Appl. No. 10/642,313  
Reply to Office action of December 17, 2004

Remarks

ANNOTATED MARKED-UP DRAWINGS

**FIG. 5****FIG. 6**

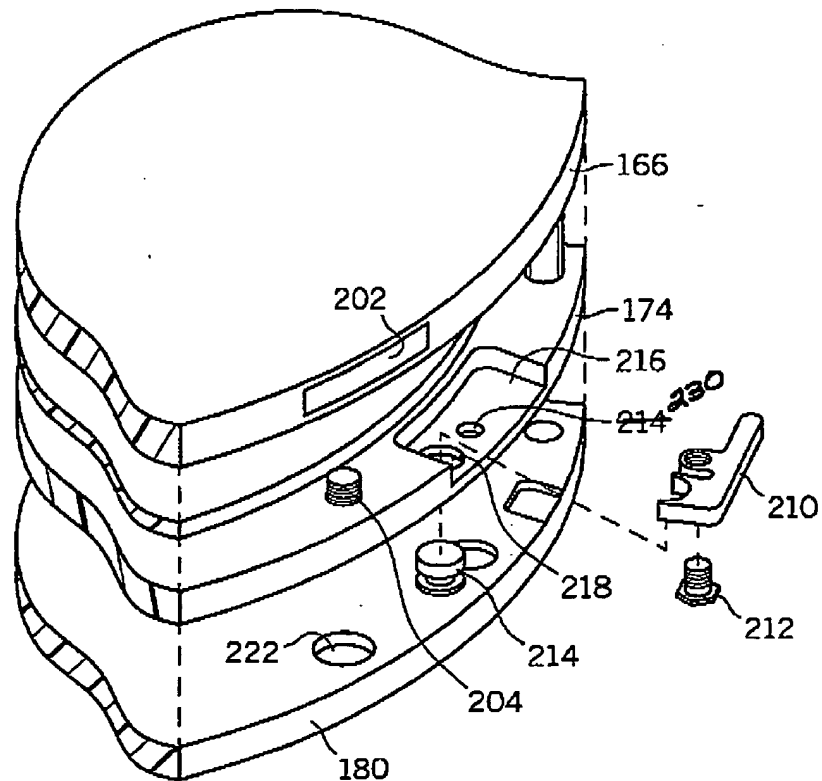
The drawings were objected to for using the same reference numeral to refer to two different elements. FIG. 8 has been amended to assign the number 230 to one of those elements. In reviewing the application, Applicants' attorney noticed that FIG. 6 suffered from the same type of error. Accordingly, FIG. 6 has been amended to apply the reference number 197 to the hollow portion of the light pin. FIG. 2 has also been amended to assign the reference
